## **+ RESPONSE TO SUBMISSIONS & BALLINA SHIRE COUNCIL'S REQUEST FOR ADDITIONAL INFORMATION**

**Proposed Lake Ainsworth Foreshore Improvement Works – Lennox Head, NSW  
Ballina Shire Council Part V Assessment No. 2017/12**

• Prepared For: **Ballina Shire Council** | • Prepared by: **DAC Planning Pty Ltd** | • **June 2018** |

Figure 1 – Figure 4 of Engineering Report  
Source: Ballina Shire Council, 3 November 2017

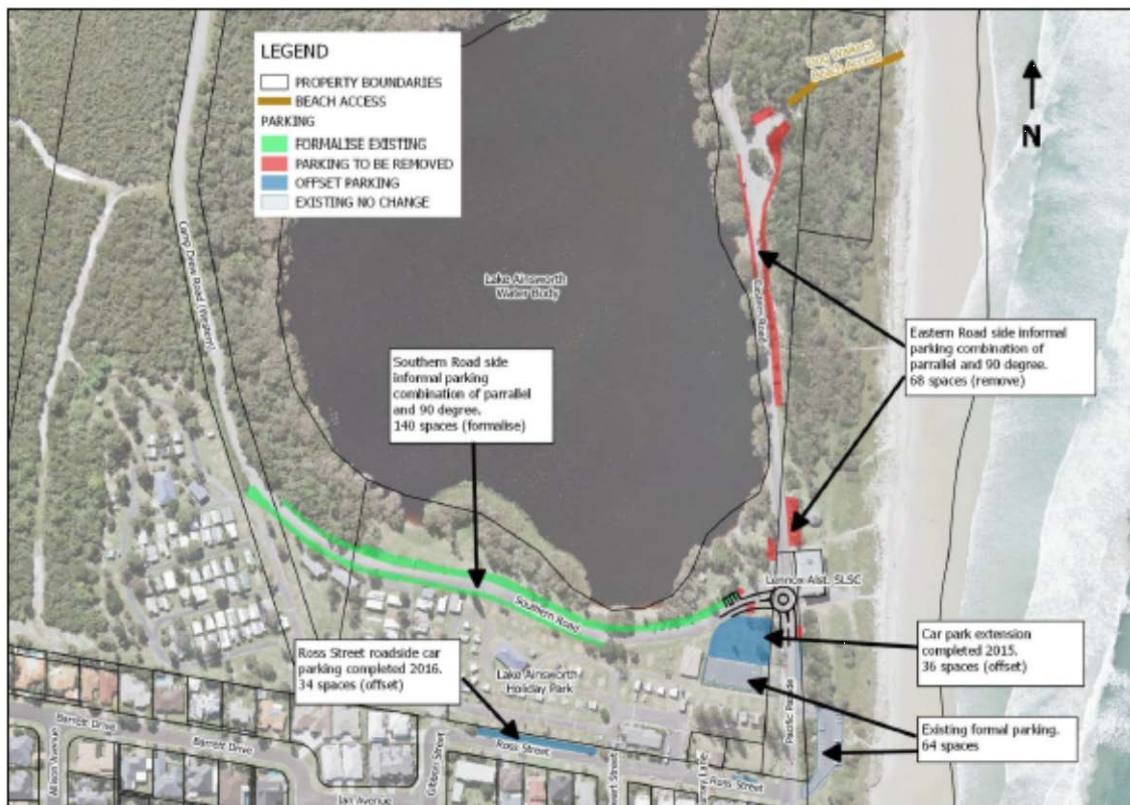
Annexure E of the Review of Environmental Factors (REF) (DAC Planning Pty Ltd, November 2017) comprises an Engineering Services Report (Ballina Shire Council, 3 November 2017). Section 3.6 of the Report addresses existing and proposed parking arrangements. In summary, there are 68 informal car parking spaces on the eastern road which will be removed to facilitate the foreshore improvement works. The proposed work includes formalising 140 spaces on the southern road, including 4 spaces for disabled persons, which is a similar number to the existing informal spaces.

To offset the loss of the 68 eastern informal car parking spaces, a new car park (36 spaces) has been constructed on the eastern side of the Lake Ainsworth Caravan Park. In addition, 34 spaces have been formalised in Ross Street. The location of the existing and proposed car parks in the context of the eastern lake foreshore is shown on **Figure 1**.
